LiDAR Quality Assessment Report

VA-MD-WV FEMA-LIDAR-R3Lot5 2012

FEMA Region3 VA LiDAR

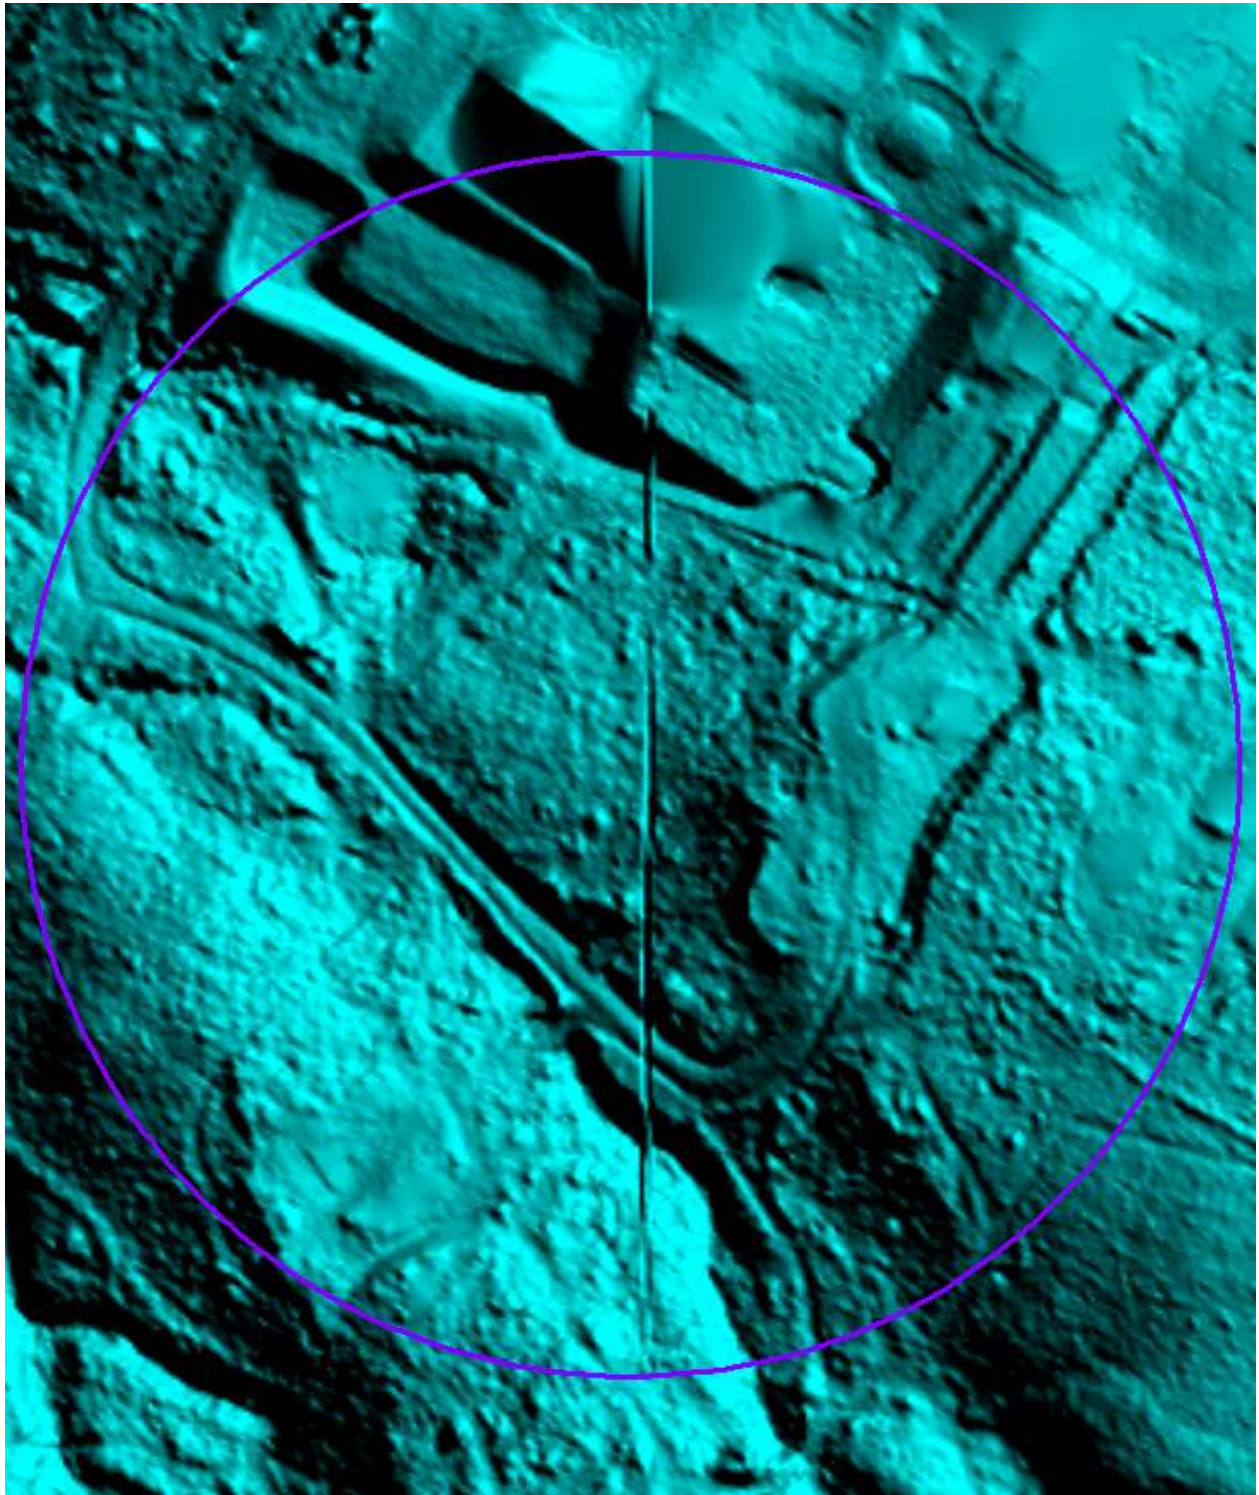
Artifact, acceptable anomaly. Scale 1:1609. Reviewer at NGTOC created a shapefile documenting the geographic location of errors and anomalies identified during DEM review. The file is named DEM_errors.shp and is located in the NED-Errors folder. Corrections received 2/8/13, accepted 2/28/13.

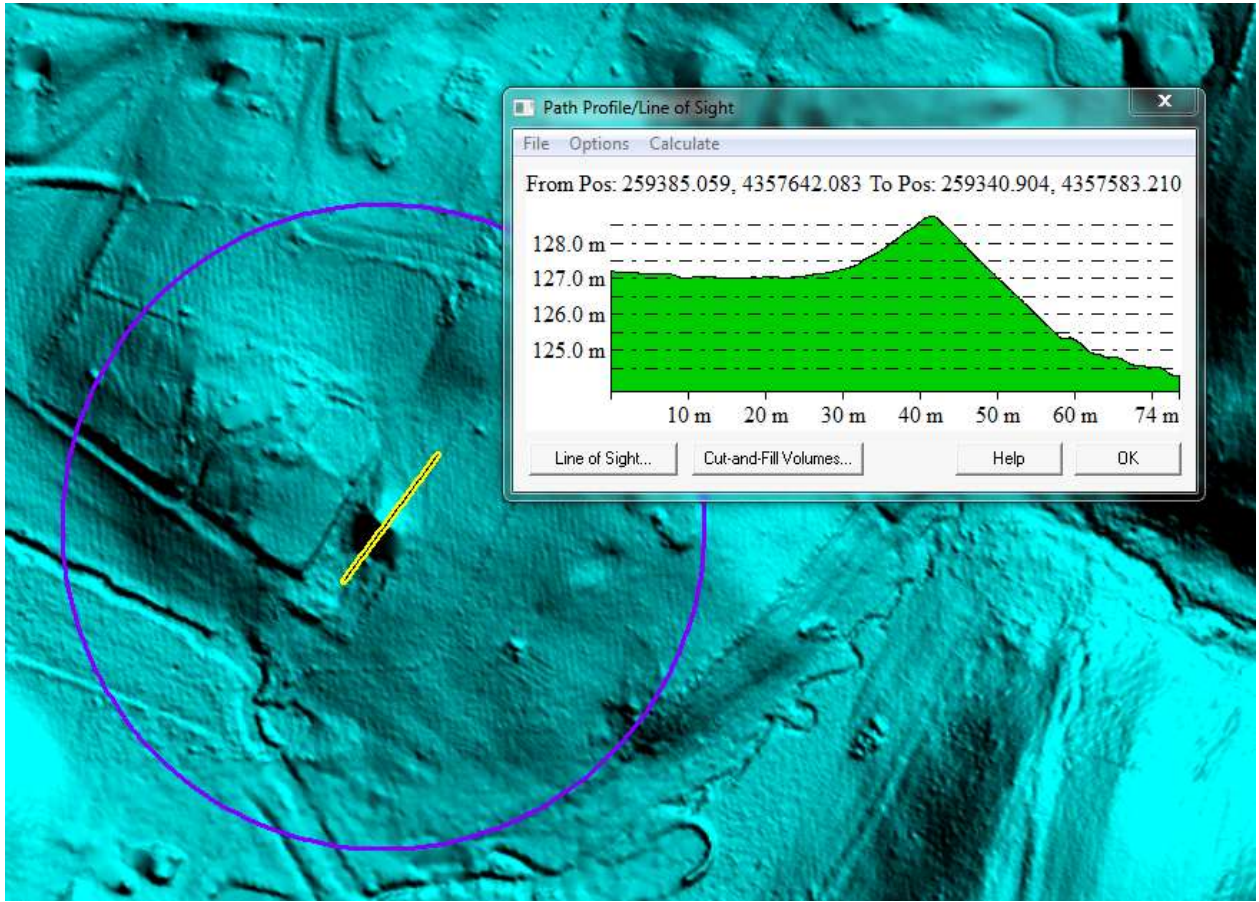
Building not properly removed from bare earth surface. Scale 1:2529. Reviewer at NGTOC created a shapefile documenting the geographic location of errors and anomalies identified during DEM review. The file is named DEM_errors.shp and is located in the NED-Errors folder. Corrections received 2/8/13, accepted 2/28/13.

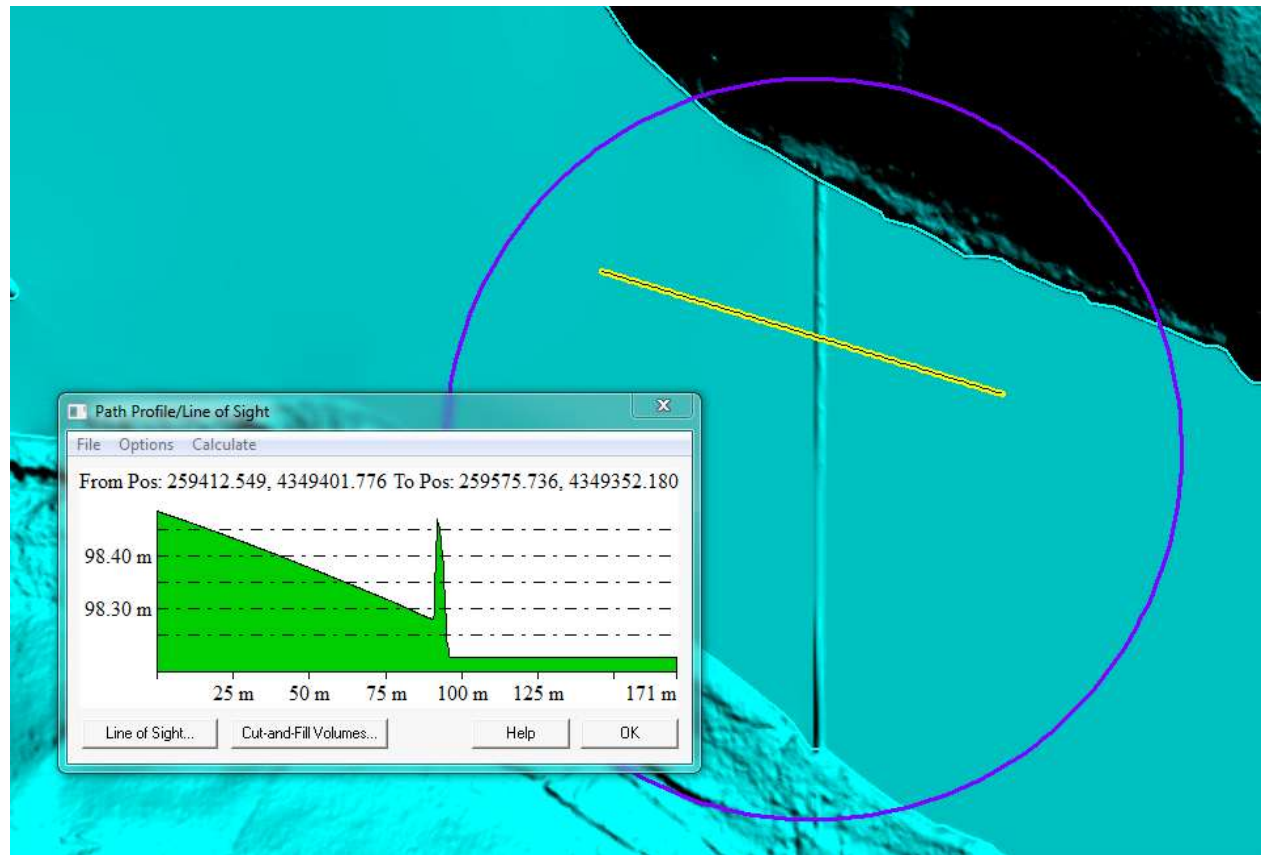
Double line stream not adequately hydroflattened. Downstream constraint not maintained. Scale 1:2016. Reviewer at NGTOC created a shapefile documenting the geographic location of errors and anomalies identified during DEM review. The file is named DEM_errors.shp and is located in the NED-Errors folder. Corrections received 2/8/13, accepted 2/28/13.

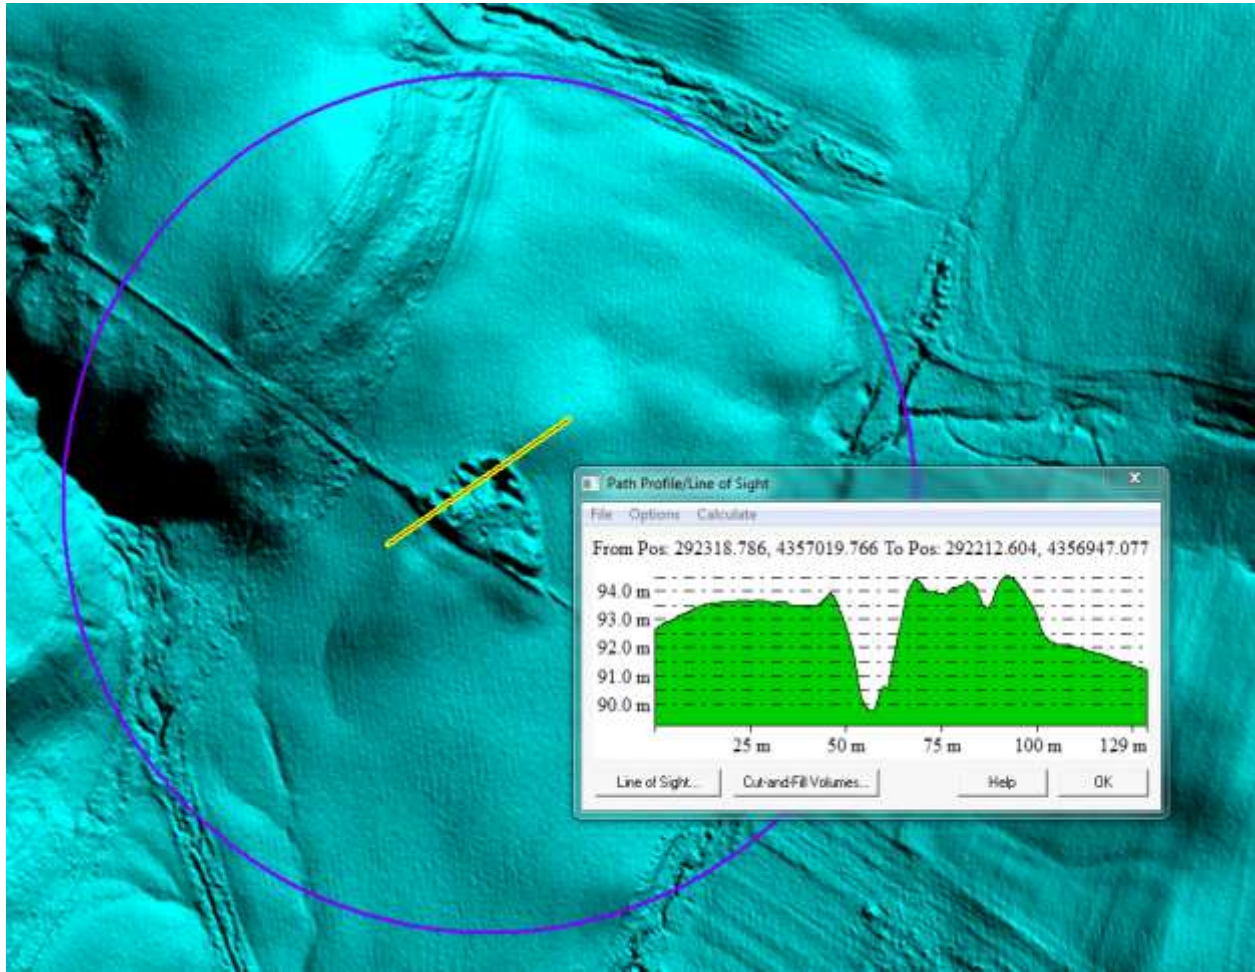
Over-removal of vegetation points resulting in pit rather than bare earth. Scale 1:2693. Reviewer at NGTOC created a shapefile documenting the geographic location of errors and anomalies identified during DEM review. The file is named DEM_errors.shp and is located in the NED-Errors folder. Corrections received 2/8/13, accepted 2/28/13.

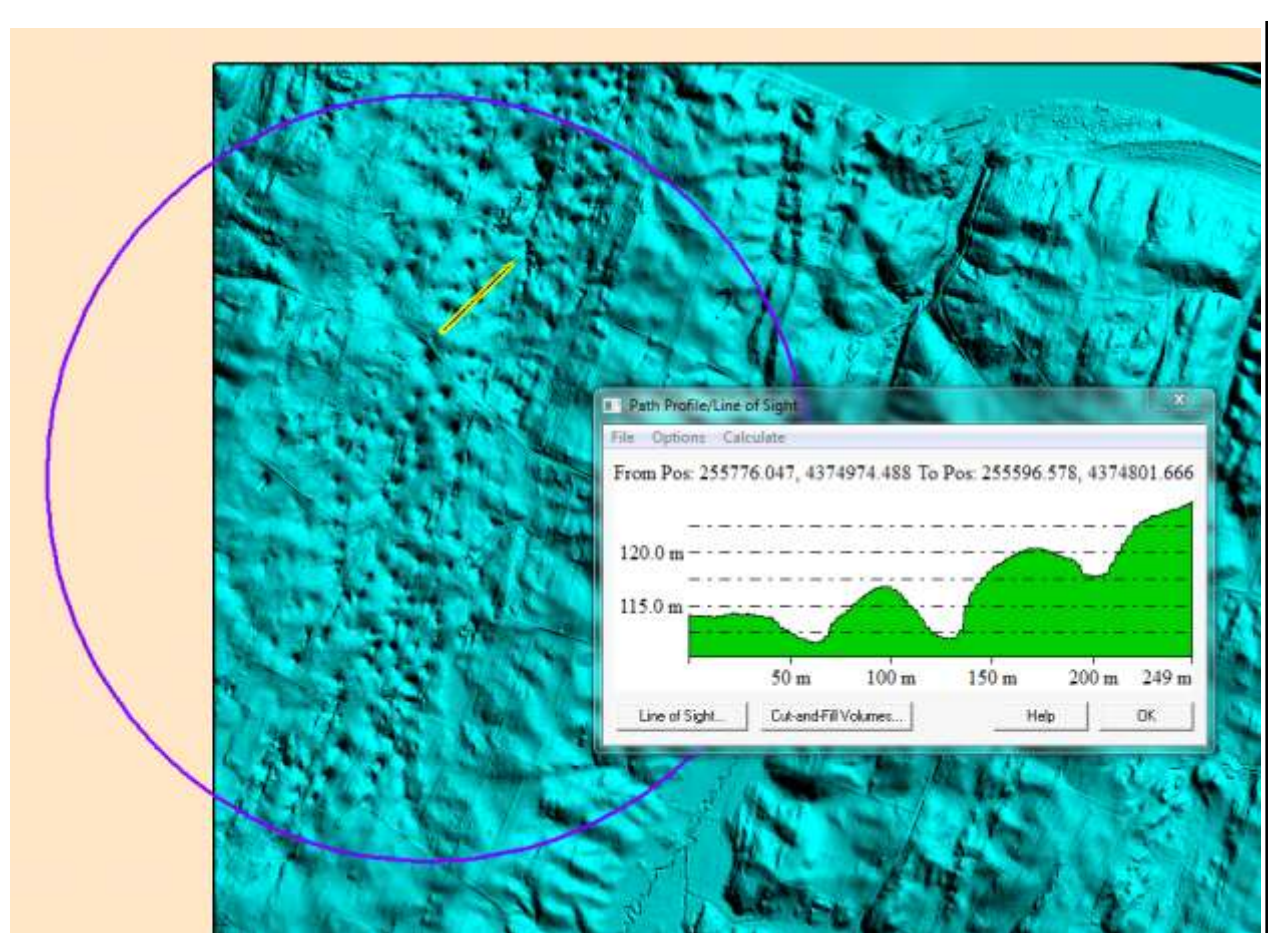
Unexplained pits near project boundary. Scale 1:12560. Reviewer at NGTOC created a shapefile documenting the geographic location of errors and anomalies identified during DEM review. The file is named DEM_errors.shp and is located in the NED-Errors folder. Corrections received 2/8/13, accepted 2/28/13.

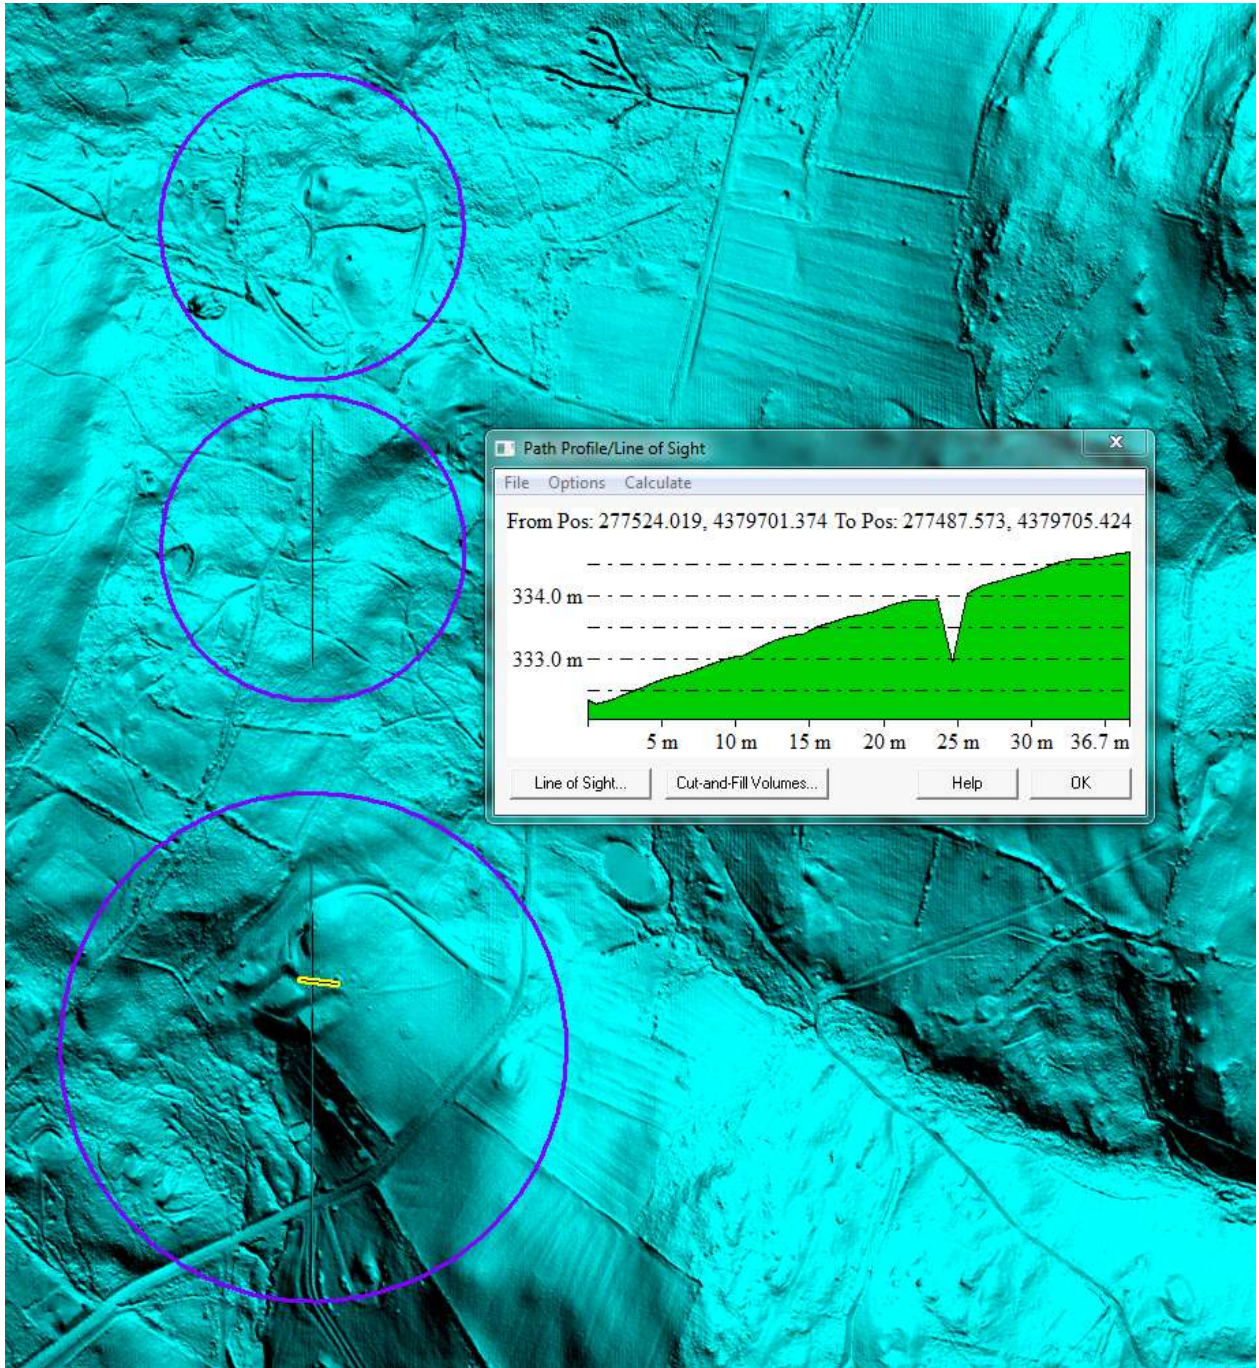
Seam line between DEM tiles 18SJT7681.img and 18STJ7781.img. Scale 1:5102. Reviewer at NGTOC created a shapefile documenting the geographic location of errors and anomalies identified during DEM review. The file is named DEM_errors.shp and is located in the NED-Errors folder. Corrections received 2/8/13, accepted 2/28/13.
